**Alcoa's Pinjarra Alumina Refinery Revised Proposal (Assessment 2253)
and Bauxite Mining on the Darling Range for 2023-2027 (Assessment 2385)**

This submission comments on both assessments. Throughout this document we referred to assessment 2253 as the Expansion. References to the Expansion ERDs are marked as '(EX chapter number - page number)'. Assessment 2385 is referred to as MMP and references to the MMP's ERDs are marked as '(MMP - 'page number')'. When referring to both, we will use the term 'the Proposals'.

WA Forest Alliance (WAFA)

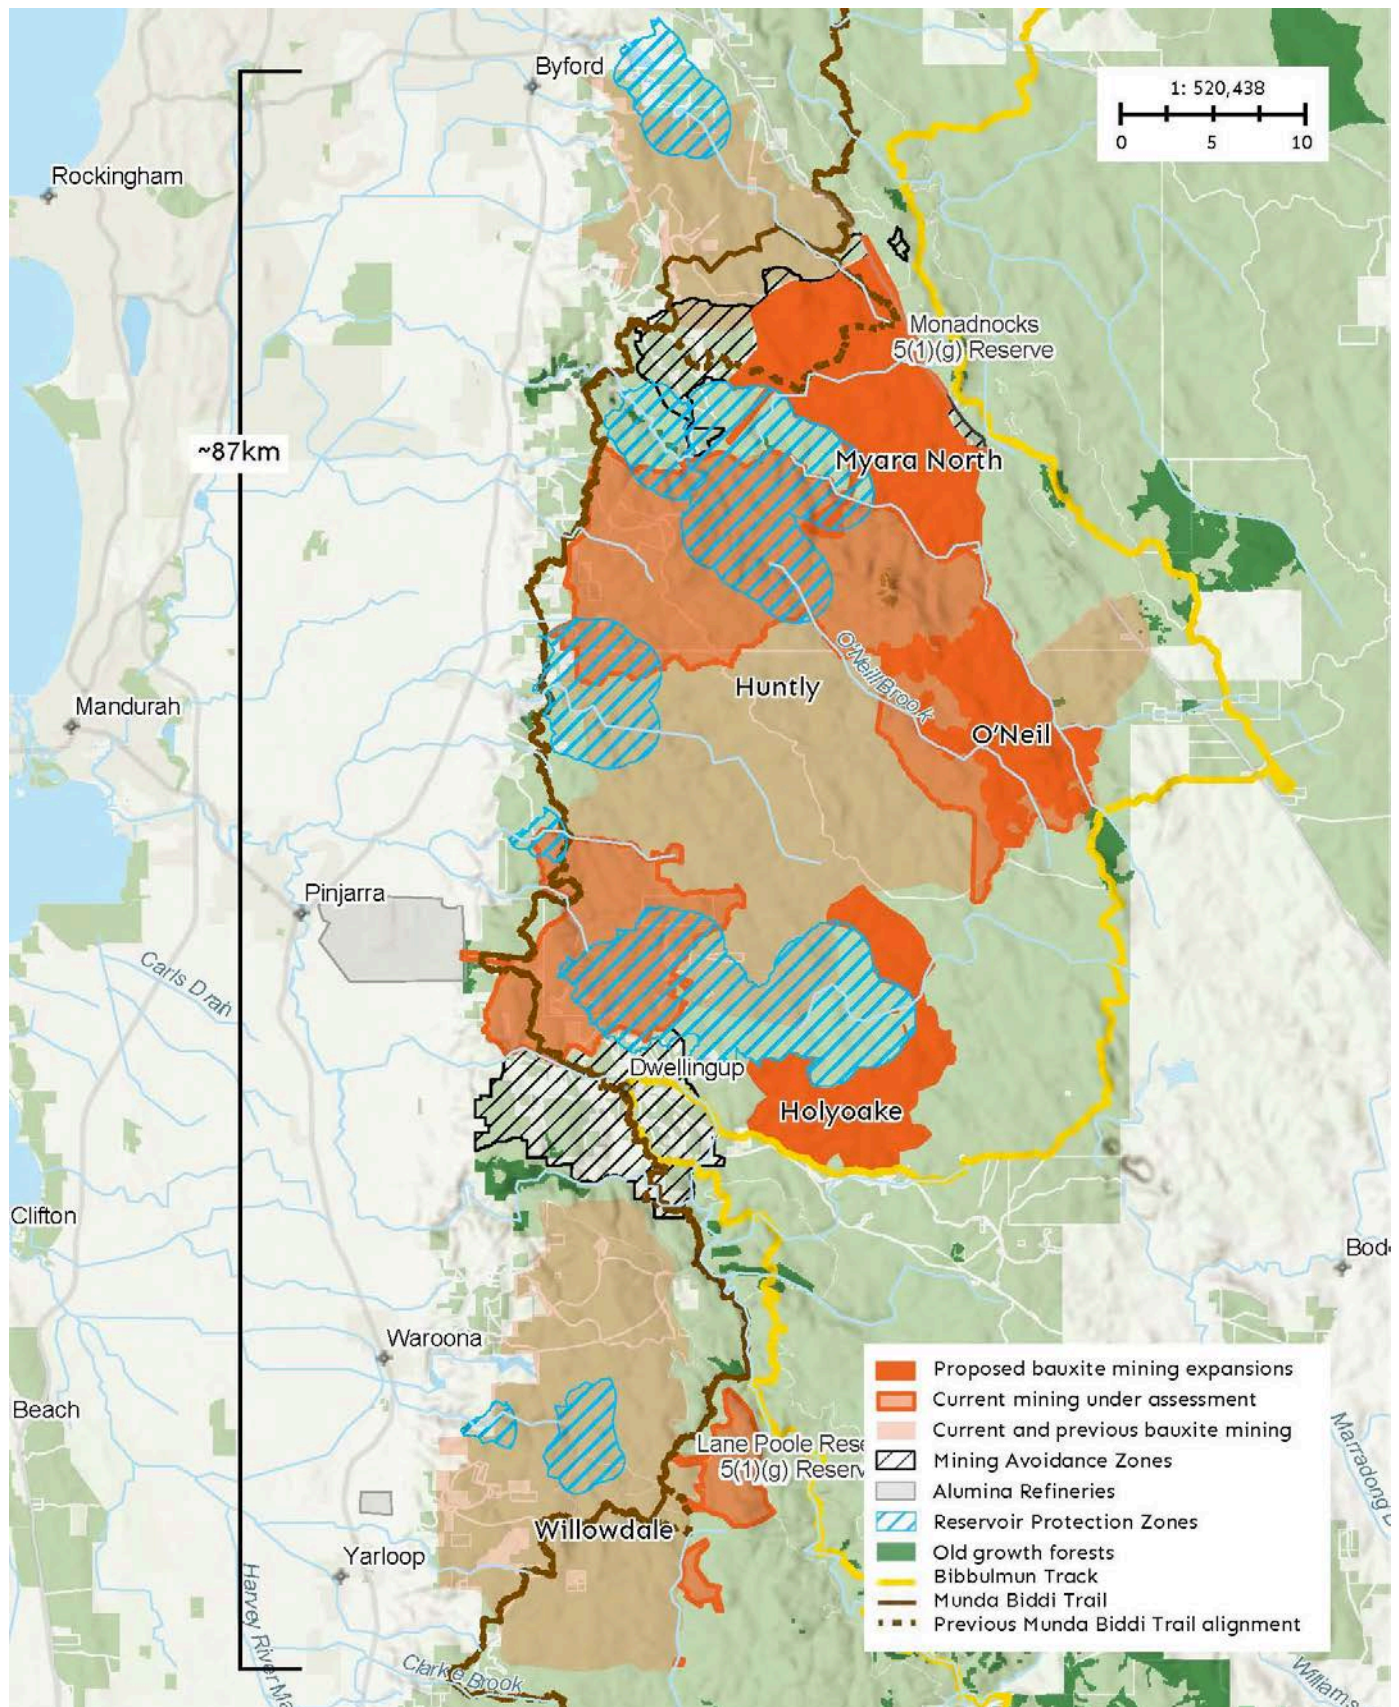
Map 1. The Expansion is shown as 'Proposed bauxite mining expansions', and the MMP areas under assessment as 'Current mining under assessment'. In addition, Alcoa's current mining, not under assessment, is shown as 'Current and previous bauxite mining'. As can be seen in Map 1, old growth forests are adjacent or within the Expansion and MMP. MMP mining and Expansion infrastructure overlap with Reservoir Protection Zones. The Expansion is also adjacent to the Bibbulmun Track, and the Munda Biddi Trail has been rerouted preemptively to avoid the Expansion.
